**Subject: MHI's Responses to US-APWR DCD RAI No. 622-4949 Revision 2**

Response to Request for Additional Information No. 622-4949,  
Revision 2

**RAI NO.:** NO. 622-4949 REVISION 2  
**SRP SECTION:** 19 – Probabilistic Risk Assessment and Severe Accident Evaluation  
**APPLICATION SECTION:** 19  
**DATE OF RAI ISSUE:** 08/30/2010

Figure 1 Layout of MCR and class 1E I&C rooms

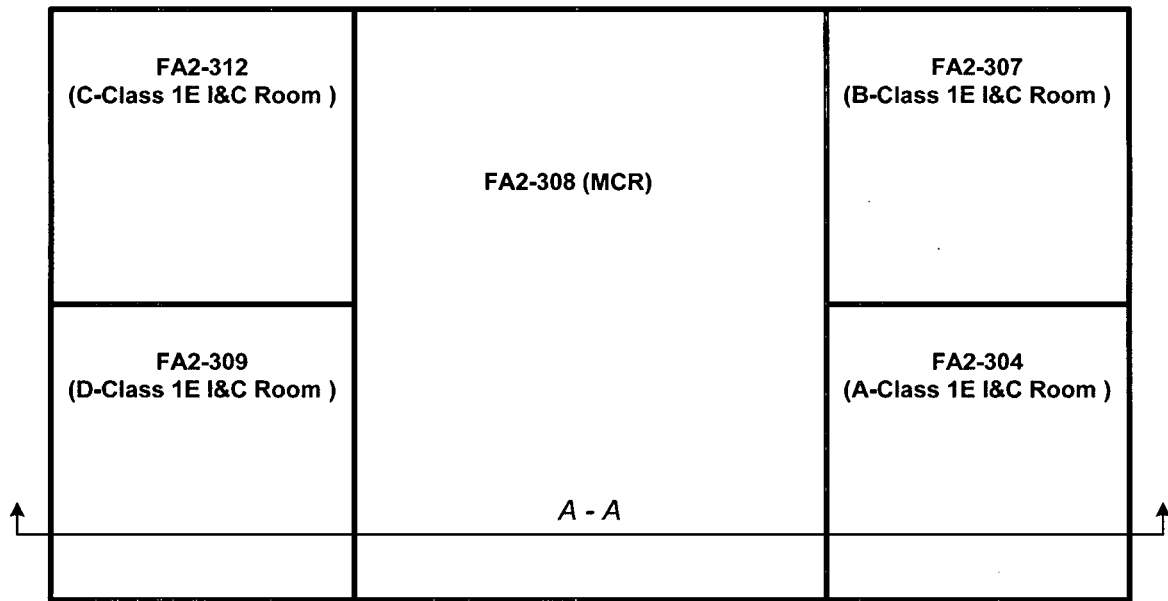
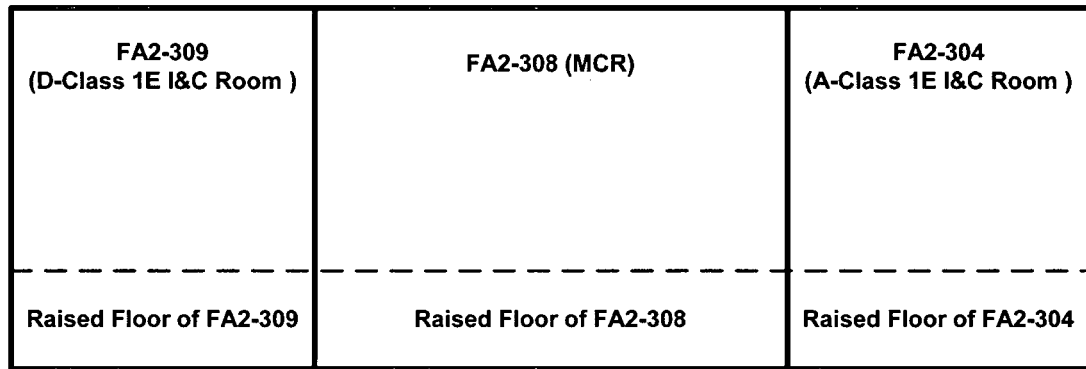
The US-APWR Probabilistic Risk Assessment Report Attachment 23N, Control Room Fires and I&C Rooms, page 23N-2 states “the boundary of each floor is not comprised of a fire resistant barrier.” Please explain how it is ensured that a fire in an I&C Room does not spread to the Main Control Room or vice versa. Please update the PRA and the DCD, as necessary, to clearly state each fire boundary between the I&C rooms and the Main Control Room and please document why a fire from an I&C Room cannot spread to the Main Control Room and vice versa.

The MCR and four I&C rooms are separated individually by fire resistant walls as shown in Figure 1. A train and B train class 1E I&C rooms are located on the east side of the MCR. C train and D train class 1E I&C rooms are located on the west side of the MCR. The boundaries of each fire area are composed of a fire resistance barrier. Every fire area is provided with the raised floor space as a fire zone, and the boundaries of the raised floor spaces and each fire area are not composed of fire resistant barriers.

In the multiple fire scenario analysis, it is assumed that a fire in each safety I&C room will propagate to the MCR with a failure of resistant barriers between each I&C room and MCR. Also, the fire scenario of each safety I&C room that propagates to the MCR will cause a loss of only one safety train.

The fire scenarios from the MCR assumed that a fire in the MCR propagates to only one safety I&C room in the multiple fire scenario analyses. This is because the potential of a coincident failure of multiple fire barriers will be very low.

Revise the Attachment 23N of the PRA report MUAP-07030(R2) to supplement the above additional information as the marked-up pages.

Figure 1 Layout of MCR and class 1E I&C rooms

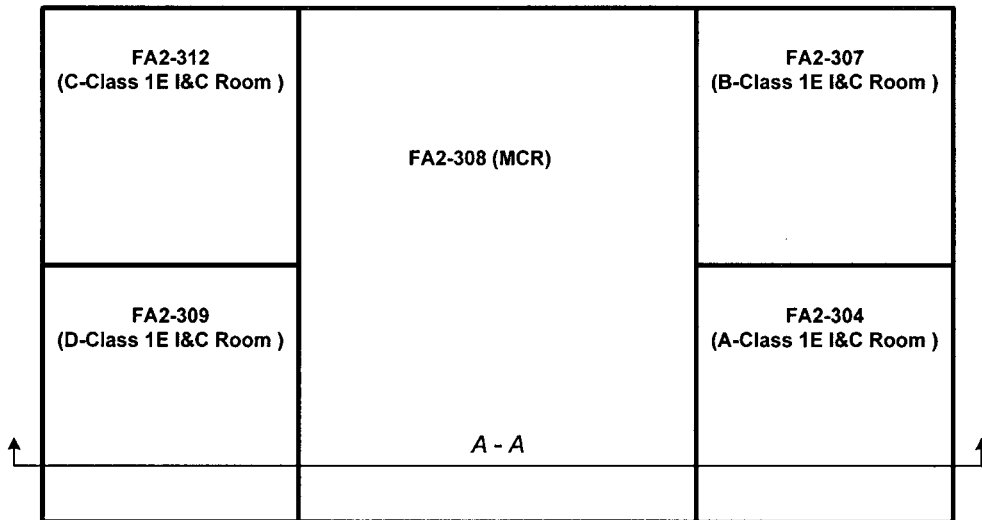
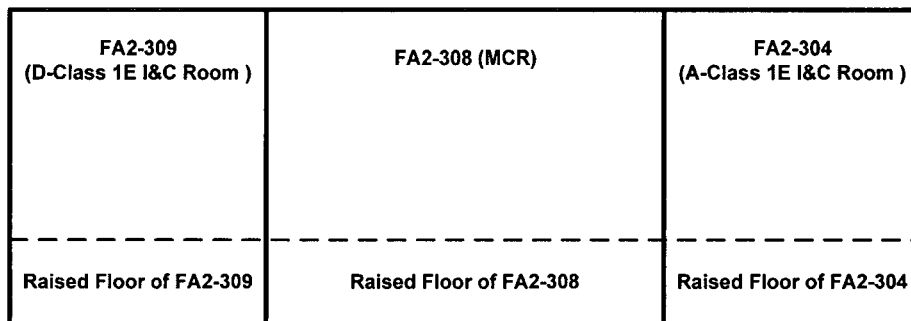
The US-APWR Probabilistic Risk Assessment Report Attachment 23N, pages 23N-5 and 23N-6 state "because the control room fire has the potential to spread to safety related I&C rooms, including raised floor spaces, with some probability, it should be confirmed that the fire scenario will not be the dominant contributor to CDF." Please explain if it has been confirmed that the fire scenario is not the dominant contributor to CDF and, if so, specifically where this confirmation can be found. The statement in Attachment 23N should also be modified, as well as the DCD, to clarify if it has been confirmed that the fire scenario is not the dominant contributor to CDF and specifically where this confirmation can be found.

The MCR and four I&C rooms are separated individually by fire resistant walls as shown in Figure 1. The MCR and the under-floor space are assigned as the same fire compartment. The boundaries of each fire area are composed of a fire resistance barrier.

The fire propagations between the MCR and each safety related I&C room are assumed in the multiple fire scenario analysis. A fire in the MCR propagates to only one safety I&C room because the probability of coincident failure of multiple fire barriers is very low. Therefore, multiple fire scenarios of the MCR have been developed assuming that a fire in the MCR propagates to only one safety I&C room.

The core damage frequencies (CDFs) of the scenarios are shown in Table 23P-1 (sheet 15 of 28 on the page 23P-17) of the Attachment 23P (multiple compartment fire scenario) of the PRA report MUAP-07030(R2). The CDFs of the multiple fire scenarios from the MCR (FA2-308) to the I&C rooms (FA2-304, FA2-307, FA2-309 and FA2-312) are not the dominant contributor to the CDF.

<u>Multiple Fire Scenario ID</u>	<u>CDF(/RY)</u>	<u>Fire propagation</u>
FA2-308-M-01	2.0E-09	FA2-308 to FA2-304
FA2-308-M-02	1.8E-09	FA2-308 to FA2-307
FA2-308-M-03	3.5E-09	FA2-308 to FA2-309
FA2-308-M-04	3.4E-09	FA2-308 to FA2-312
